Re: Minor Project Refinement No. 20 for the South Orange County Reliability Enhancement Project.

South Orange County Reliability Enhancement Project CPUC Minor Project Refinement Form

SOCRE PROJECT
MPR-20
San Clemente
Orange County, CA

ATTACHMENT B
MPR-20 Figure

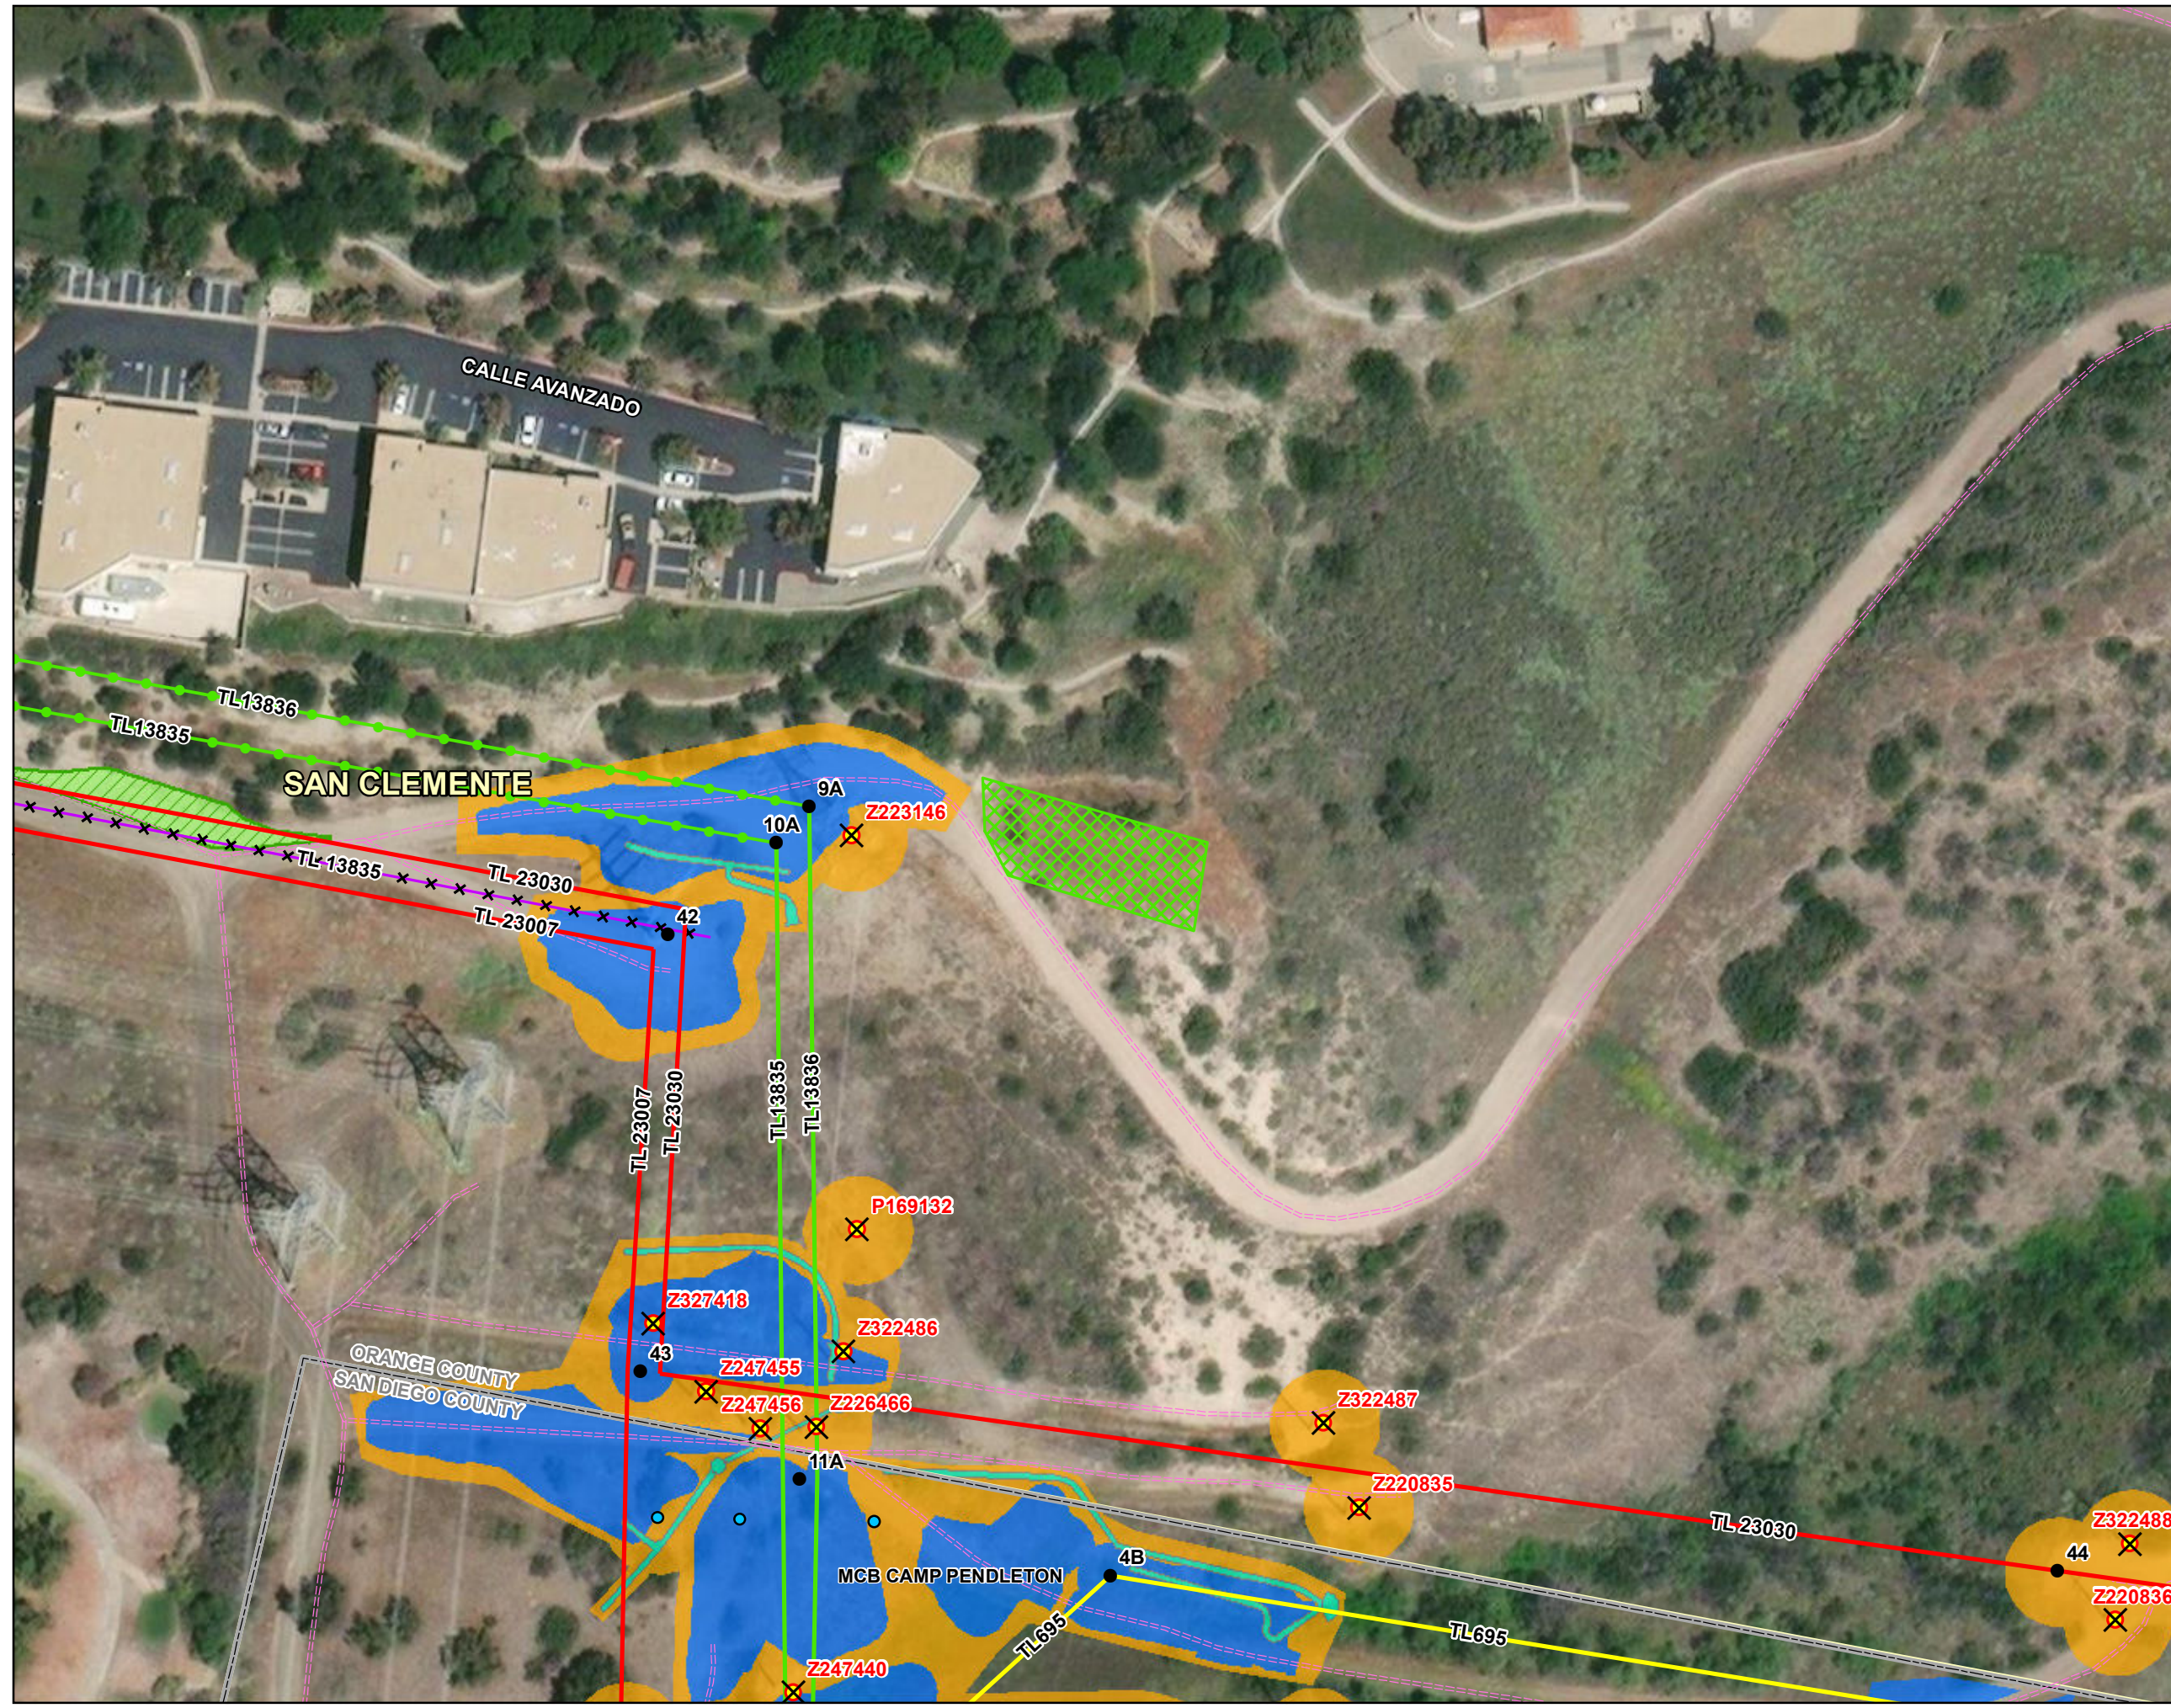
San Diego Gas and Electric (SDG&E) is requesting approval of MPR-20 for the use of a new temporary work area for the South Orange County Reliability Enhancement Project (SOCRE or Project). The new temporary work area is located immediately east of the approved Location 9A work area, as shown in **Attachment B, MPR-20 Figure**. Location 9A was previously approved in Notice to Proceed No. 7 (NTP-7). The new MPR-20 work area will total approximately 5,130 square feet (0.12 acre).

The MPR-20 temporary work area will be utilized as a temporary laydown area for sections of lattice tower during the removal of Z223146 as part of NTP-7 transmission line construction activities. The remove-from-service (RFS) structure will be accessed from the west via the existing access road,

and the crane required for structure dismantlement will be staged on the eastern end of the maintenance pad for Location 9A. The cut sections of the lattice tower will be hauled away by a trailer as described in Section 2.4.5.4 of the Final Environmental Impact Report (FEIR). The vegetation within the work area will be left in place and drive and crush methods will be employed. A water truck will be utilized to dampen the area prior to drive and crush to mitigate fire risk. Plywood may also be placed on top of the vegetation within the work area to accommodate the sections of lattice tower within the MPR-20 work area while preserving the vegetation underneath.

Justification for Change: Following constructability review in the field, the construction contractor identified the need for the additional MPR-20 work area to safely facilitate the removal of Z322146 from service. The existing maintenance pad for Location 9A is unable to accommodate the temporary laydown of the lattice tower due to the proximity of energized lines, newly set poles, and minimum approach distance (MAD) precautions required within the work area. The crane will occupy approximately 40 ft. x 40 ft. of the available space on the eastern end of the maintenance pad for Location 9A, in addition to the flatbed truck required for hauling the sections of tower away staged behind the crane on the eastern access road. Therefore, the substantial size of the cut sections of lattice tower cannot be supported within the constraints of the existing work area while all other necessary pieces of equipment for its removal are present. Therefore, MPR-20 is proposing the use of the additional temporary work area and associated land disturbance that was not originally included in NTP-7, but is necessary to construct the Project as described in Section 2.3.3.1 of the FEIR.
